Replacing PE4302 with PE4312

Application Note 60

Figure 1 • PE4302 Application Circuit

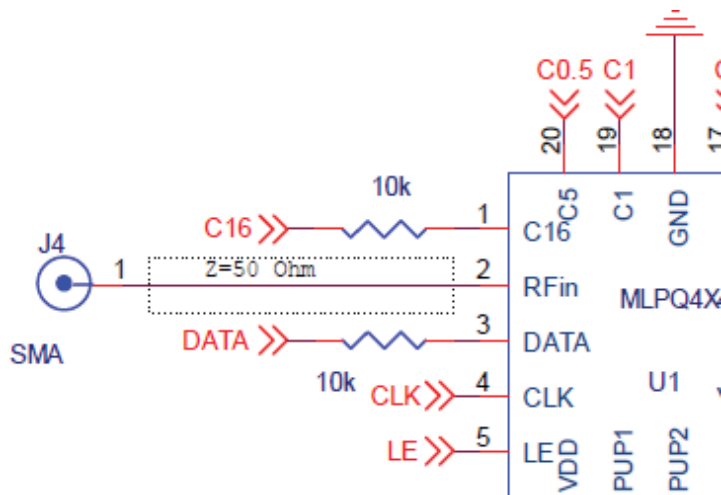
The PE4302 application circuit contained two resistors in the C16 and DATA lines.

These resistors were originally placed to remove a resonance between the RF_{IN} pin and the connection to the adjacent pins. This resonance caused degradation in the PE4302 DSA performance above 2.5 GHz. The PE4312 does not need resistors on the C16 or the DATA line and it is preferable to remove them or reduce the values so the logic threshold levels are met.

Users should ensure that the PE4312 logic levels are compatible with the data levels in the design. If the series 10k resistor is left in the circuit on the DATA line or if the clock period is too short, the data V_{IL} threshold may not be met in the high to low transition.

The PE4312 can successfully be used to replace the PE4302 in an existing design with appropriate consideration for the logic levels and removal or reduction in value of the DATA line resistors. The PE4312 can also be used in new designs based upon an older PE4302 design provided the maximum digital input voltage remains 3.3V.
